Heaton Primary Accessibility Action Plan April 2023

4.1 - ACTION TABLE

13.11

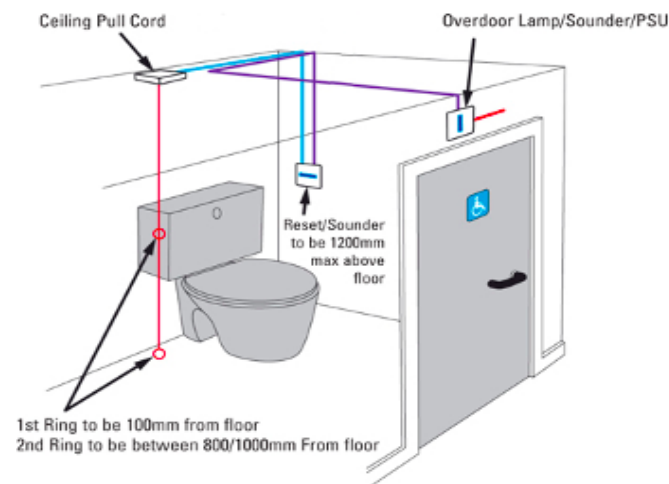
The cord alarm was marginally high from ground floor level in facility 270.

The years 5 and 6 facility featured a cord alarm that was tucked behind a pipe, high from ground floor level.

If a cord alarm is not within a suitable distance from ground floor level, a distress call may go unnoticed.

Implement a management procedure to ensure that cord alarms are always kept loose and not tied up.

☑
According to BS8300 - An emergency assistance pull cord should be sited so that it can be operated from the WC and from an adjacent floor area. The emergency assistance pull cord, coloured red, should be provided with two red bangles of 50 mm diameter, one set at a height between 800 mm and 1000 mm and the other set at 100 mm above floor level.

Cord untied in Green base Toilet

15.3

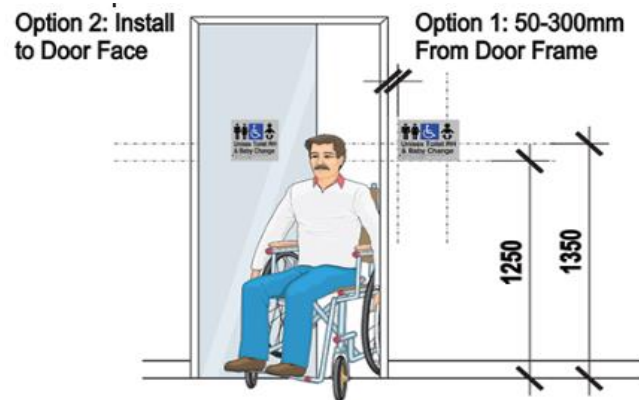
The signage on facility 42 was slightly damaged.

The Hygiene Room 270 was not suitably signed for its purpose.

The WC facility 171 in years 5 and 6 was not suitably signposted.

The appropriate toilet signage should be provided. As well as signage on the toilet doors, there should also be signs indicating where the accessible WCs are located.

BS8300 states - Information and direction signs should be provided at each point where they are required, e.g. at junctions of circulation routes, at key locations such as doorways and reception points, at facilities such as telephones and toilets, and in rooms, spaces and counters. The colour, design and typeface of signs should be consistent throughout a building.

All accessible WC door signage should ideally be accessible to all disabled people with Braille and embossed lettering preferred.

Raised lettering / Braille Toilet signs added to 3 doors 263,270 & 171
